Plugs and socket-outlets for household and similar purposes – Part 1: General requirements

IEC 60884-1

Edition 3.0 2013-02

AMENDMENT 2
AMENDEMENT 2

Figure 41 – Apparatus for pressure test at high temperature

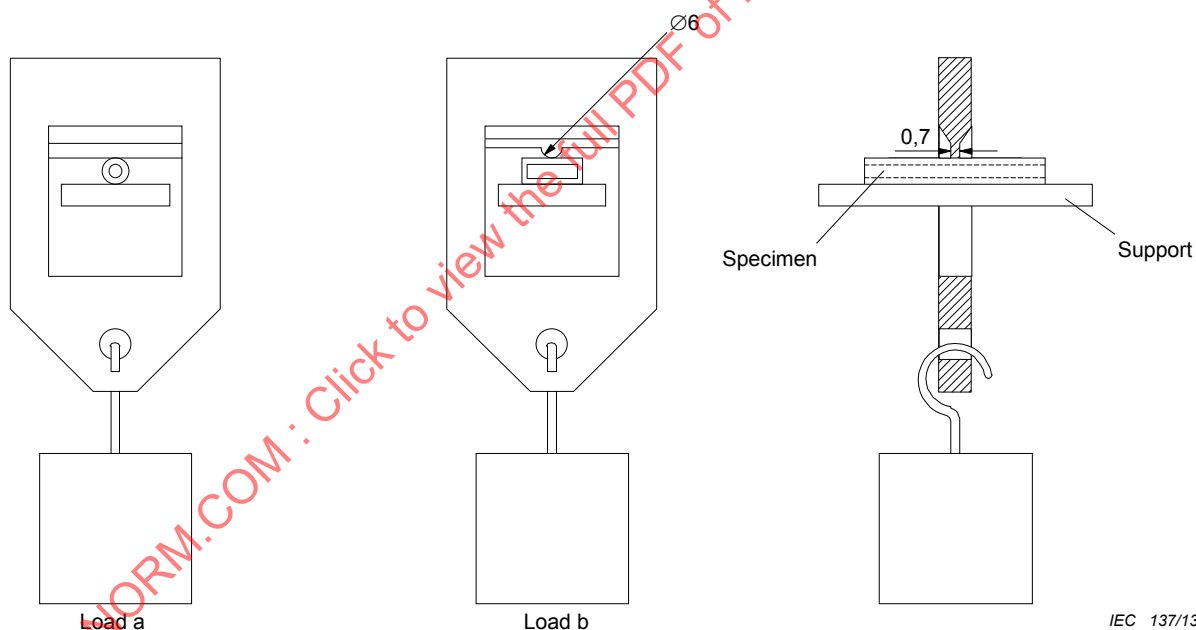
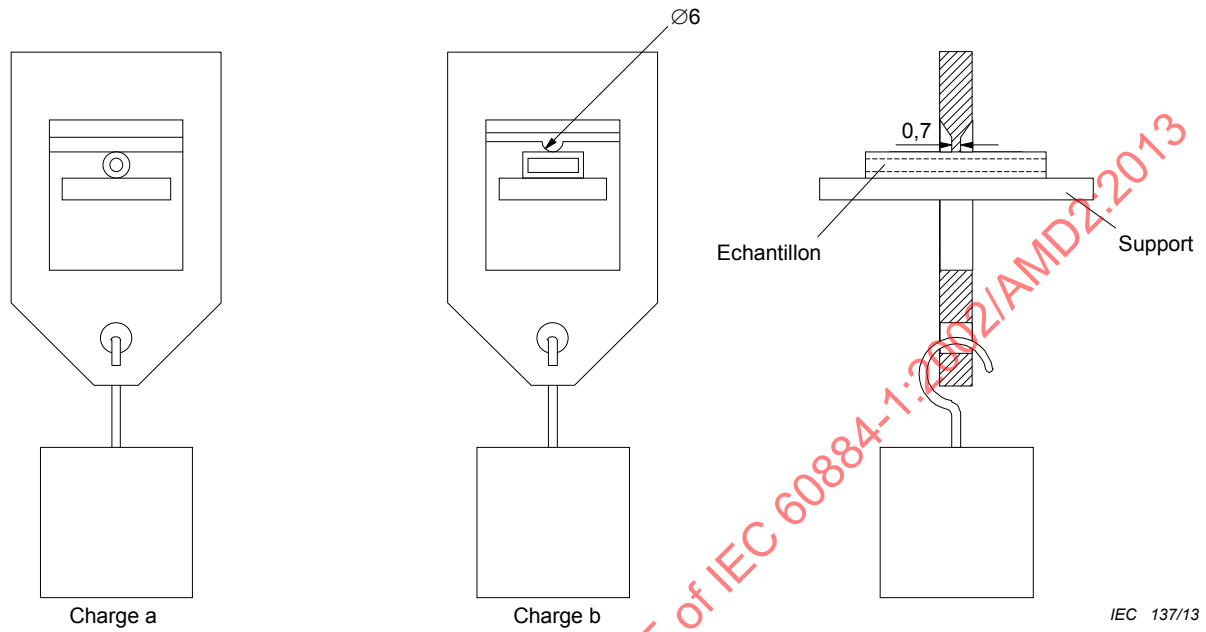
Replace the existing Figure 41 by the following new Figure 41:

Figure 42 – Impact test apparatus on pins provided with insulating sleeves

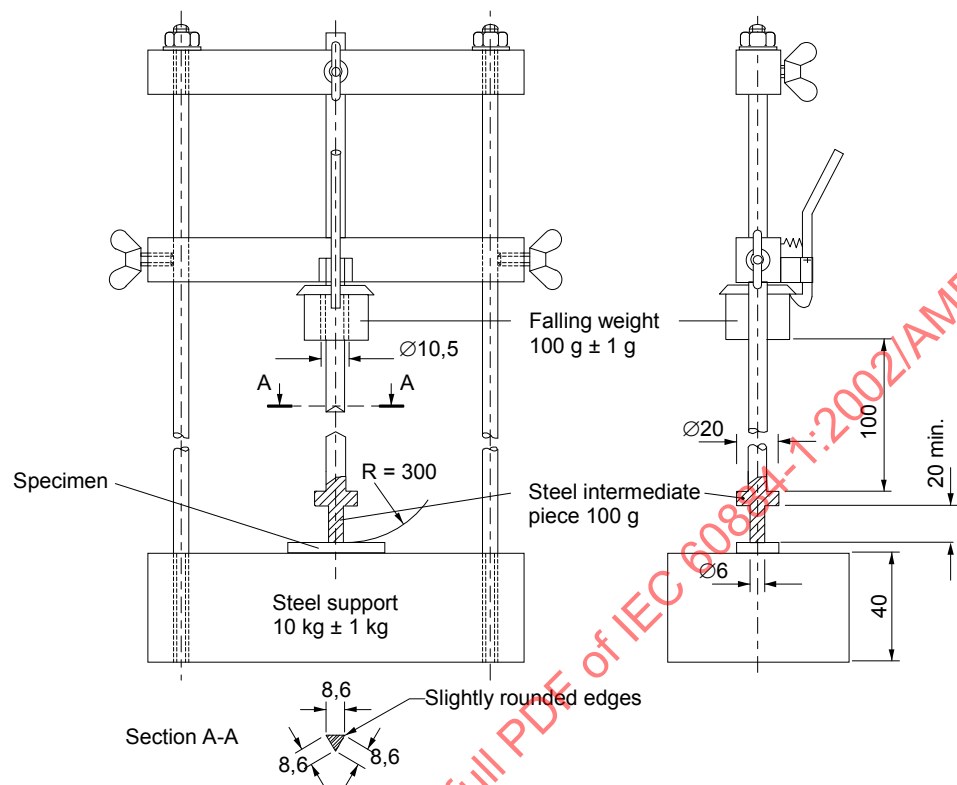
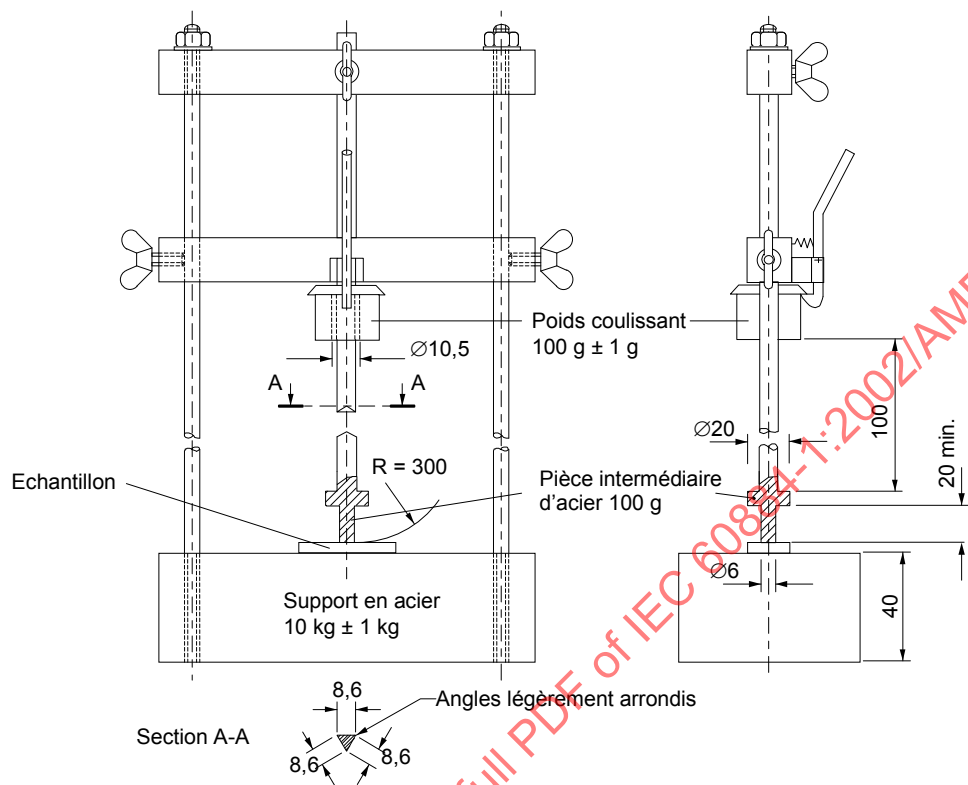
Replace the existing Figure 42 by the following new Figure 42:

Figure 44 – Clamping unit for the temperature rise test of Clause 19

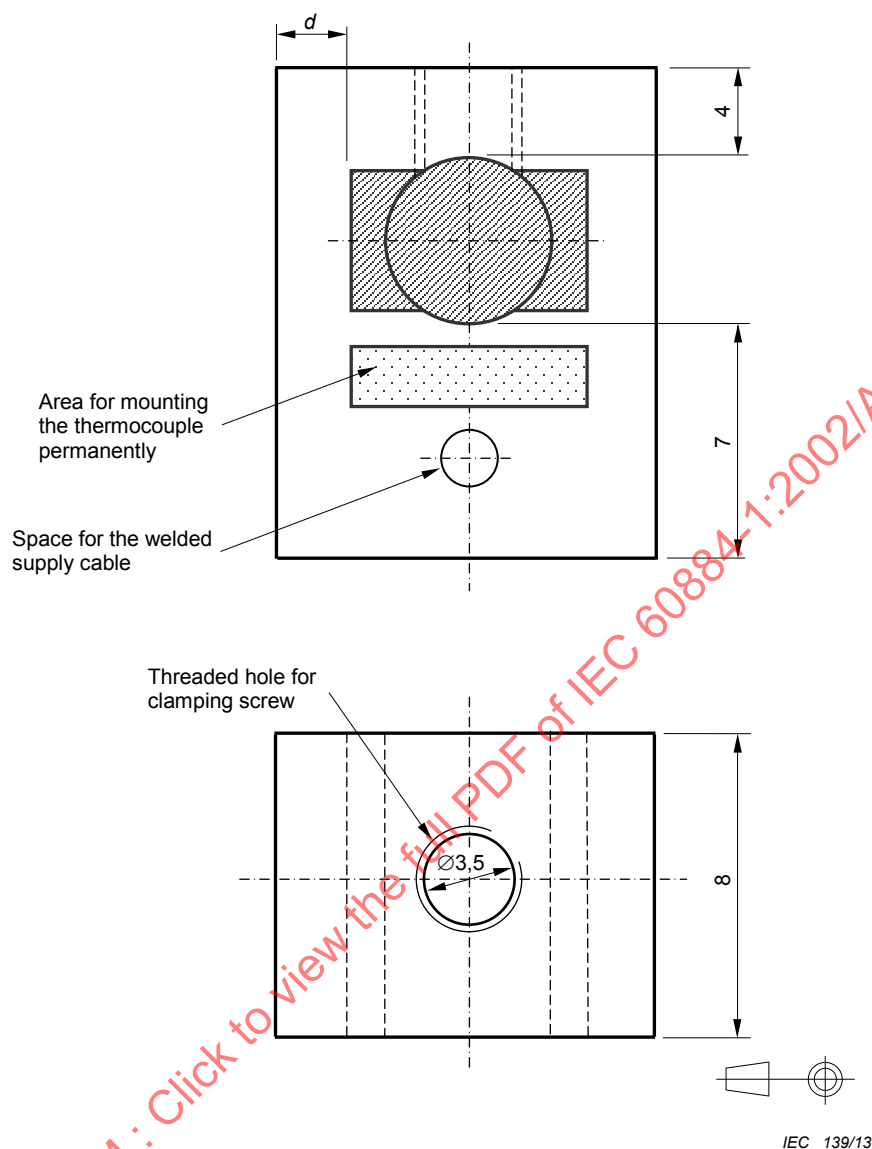
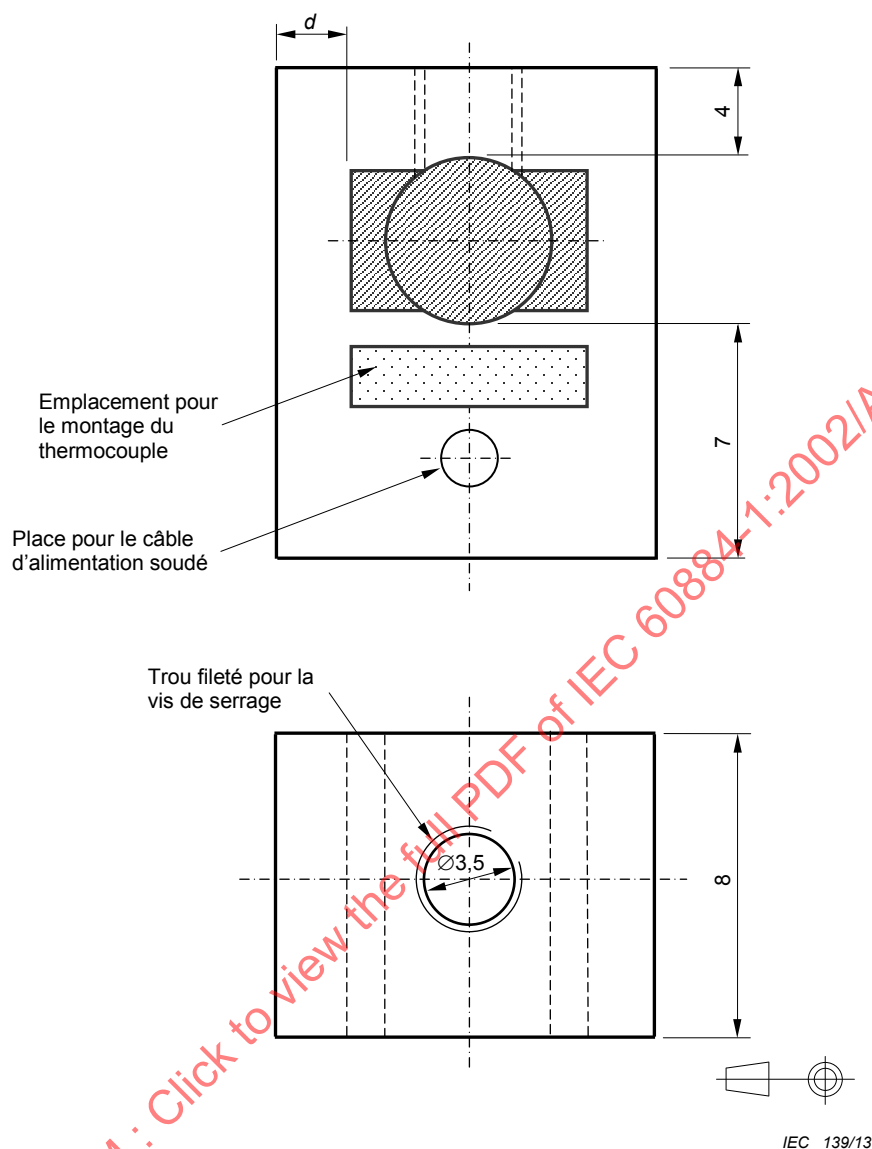
Replace the existing Figure 44 by the following new Figure 44:

- The dimension(s) for the shaded area is(are) the maximum plug pin dimension(s) + 0,8 mm.
- $1,5 \leq d \leq 3$.
- The thermocouple should be placed within the shaded area but not directly under the clamping screw.

Figure 45 – Examples of membranes and grommets

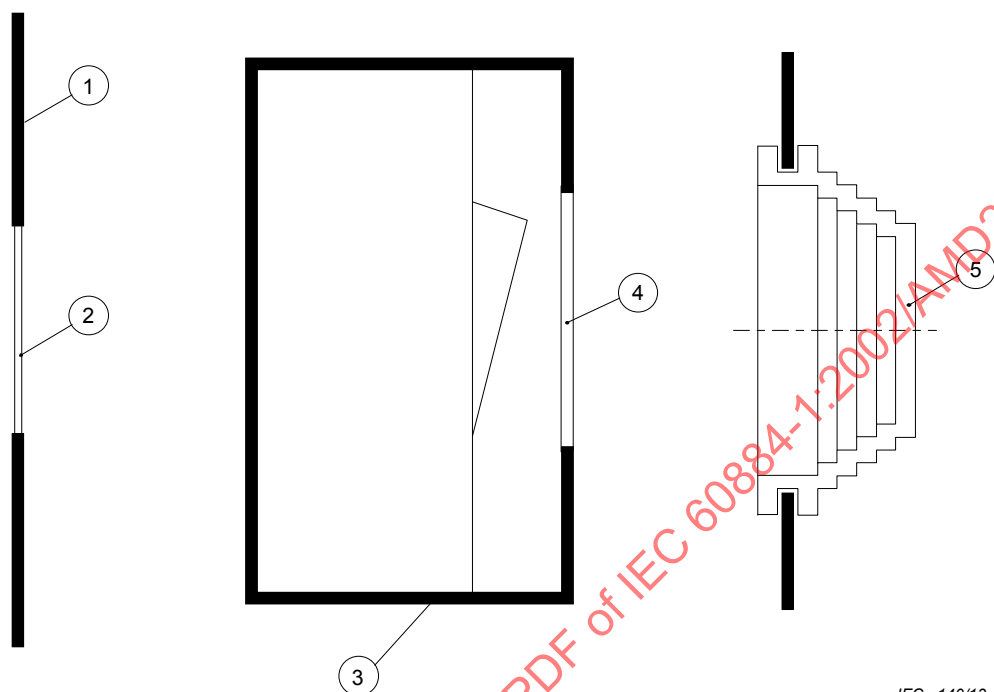
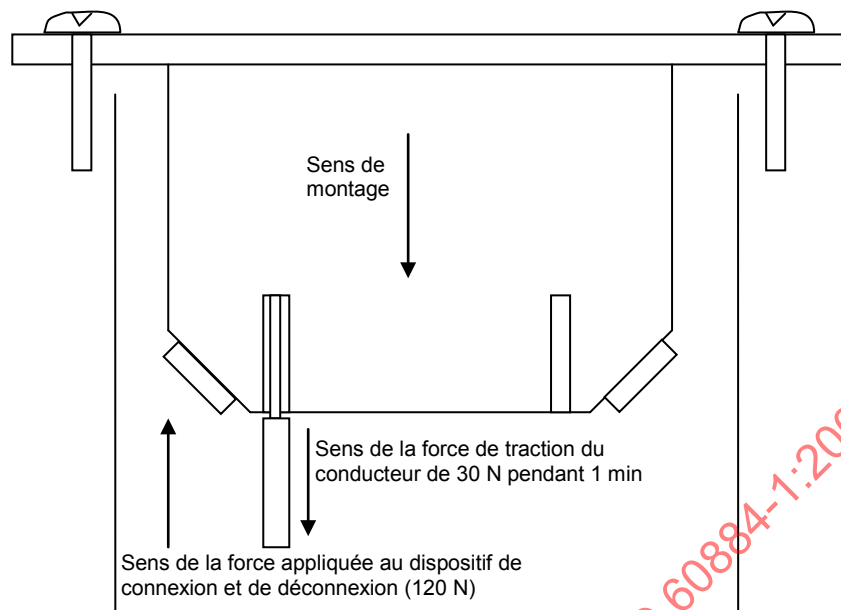
Add, after Figure 44 of IEC 60884-1:2002 as amended by Amendment 1:2006, the following new Figures 45 and 46:

- 1 Box
- 2 Entry membrane
- 3 Envelope
- 4 Protective membrane
- 5 Grommet

Figure 46 – Verification of the requirements of 13.4

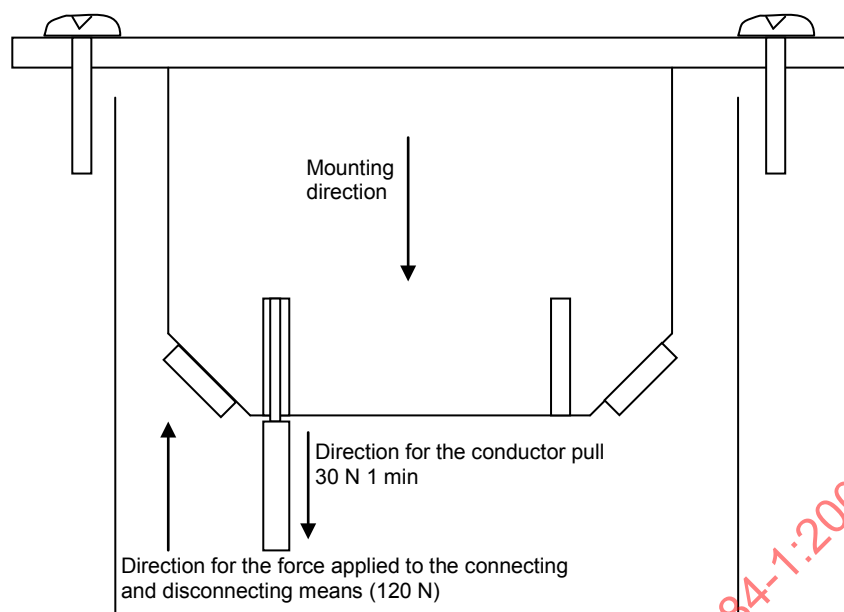
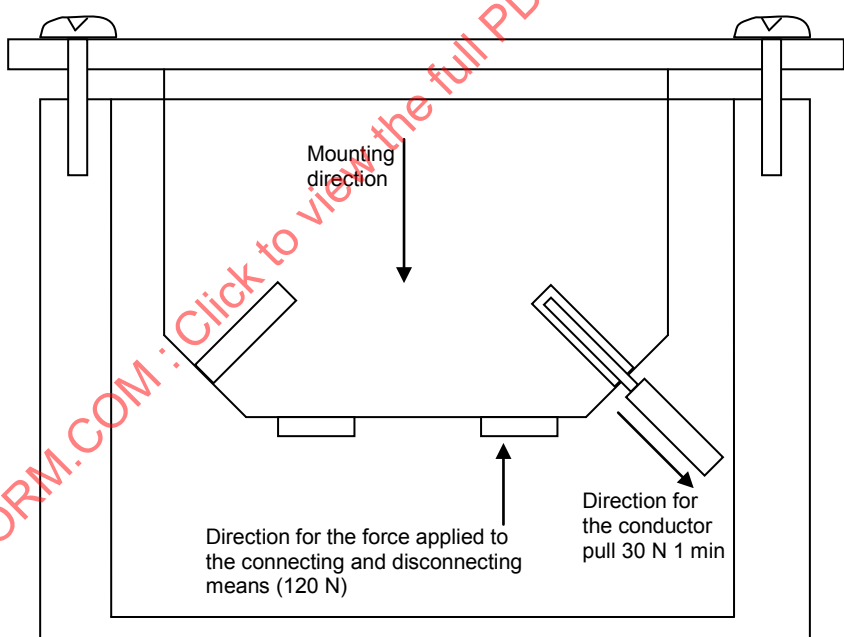
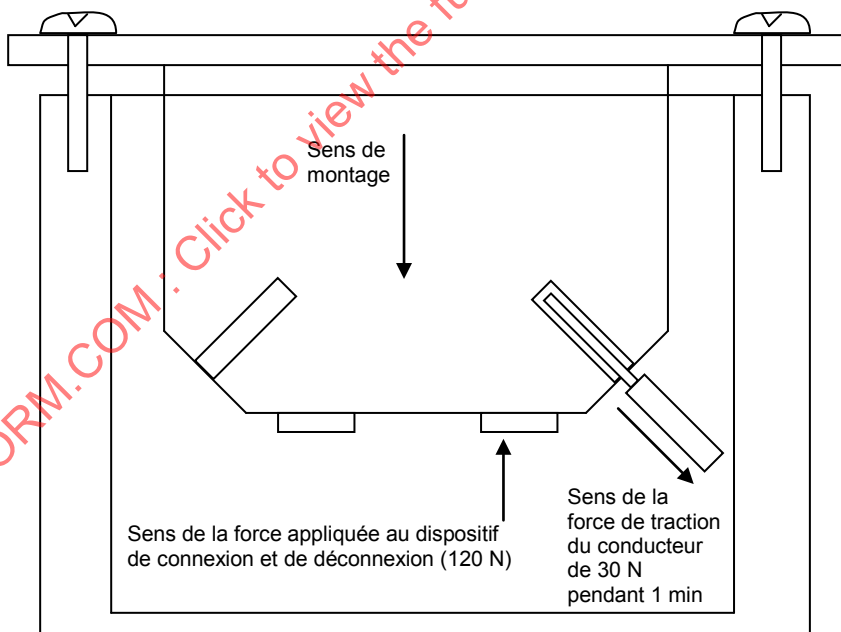
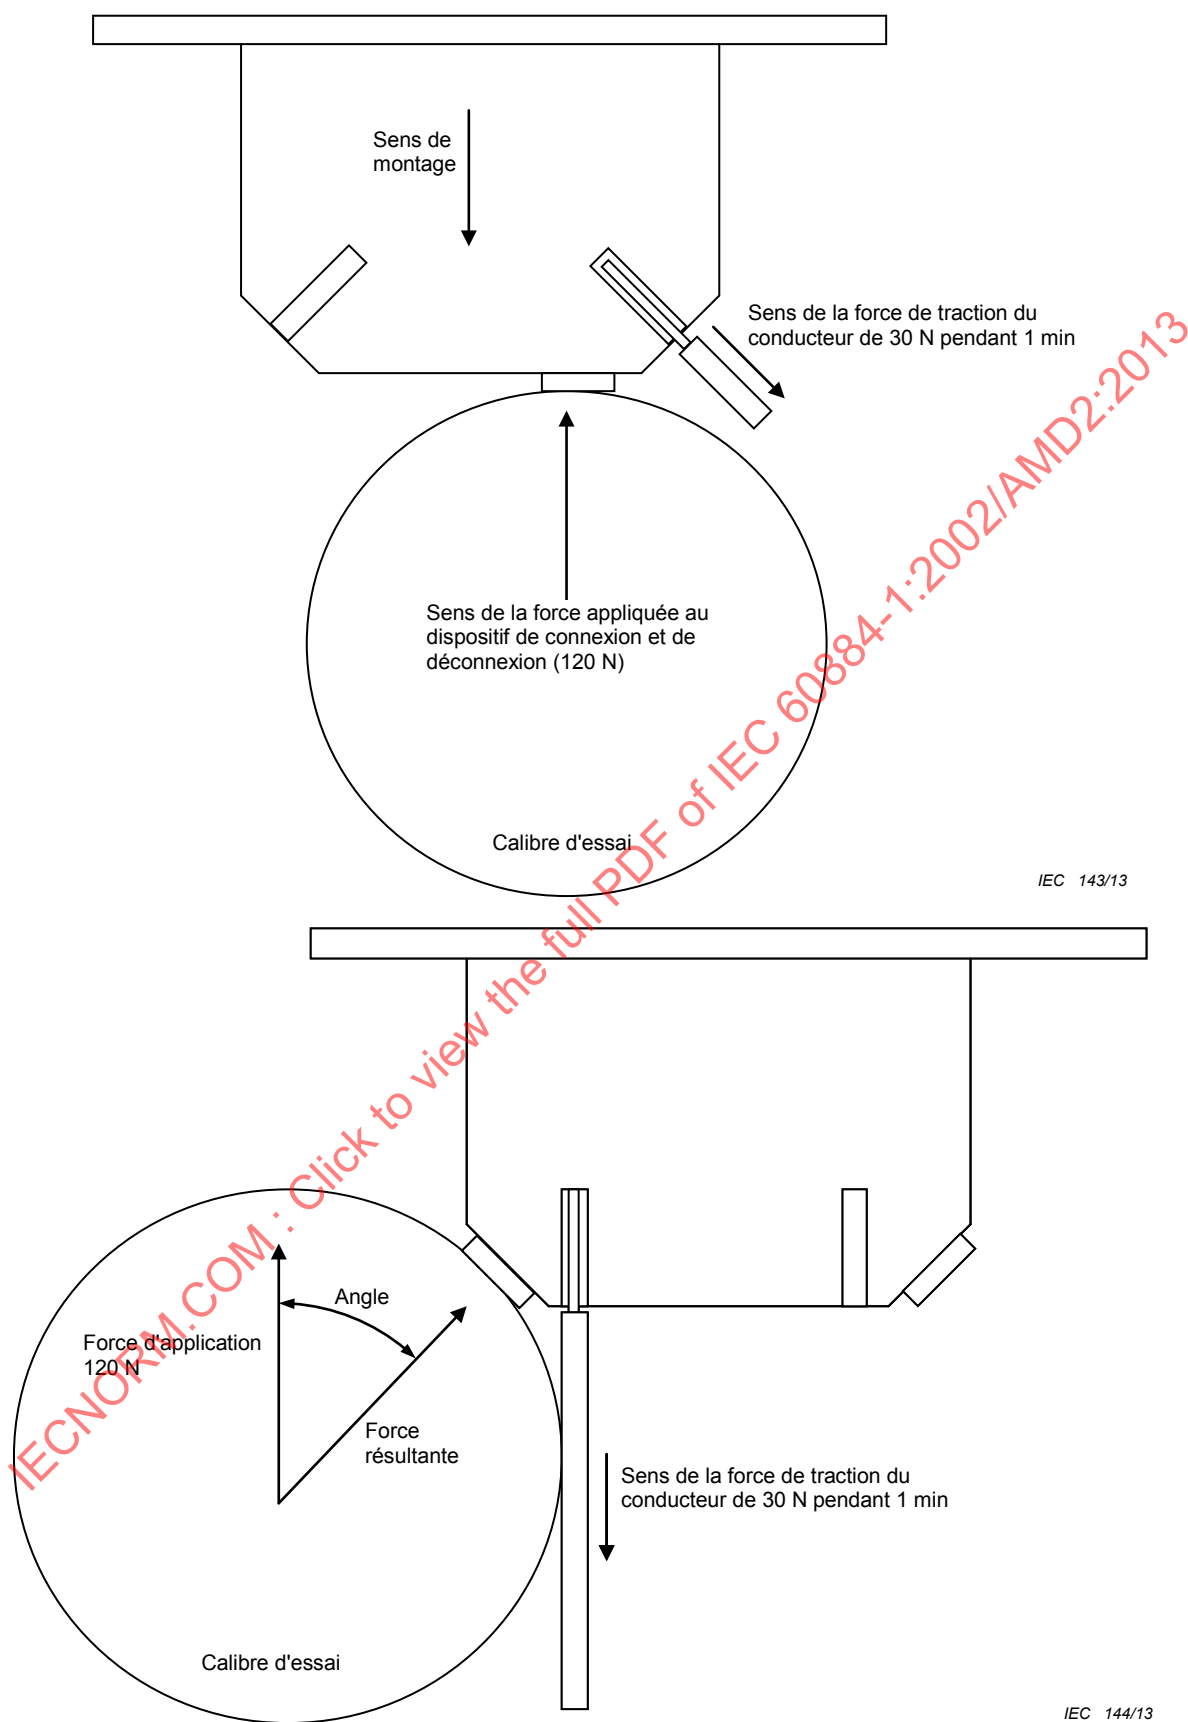
A test probe according to IEC 61032 test probe 1 is pushed against the connecting or disconnecting means with a force of 120 N in the direction opposite to the mounting direction as described in Figure 46a.

Where the axis between the application force and the axis through the force necessary to operate the connecting/disconnecting means deviates by more than 20°, it is allowed to exert the calculated resulting force directly onto the connecting/disconnecting means using the test probe; an example is shown in Figure 46b.
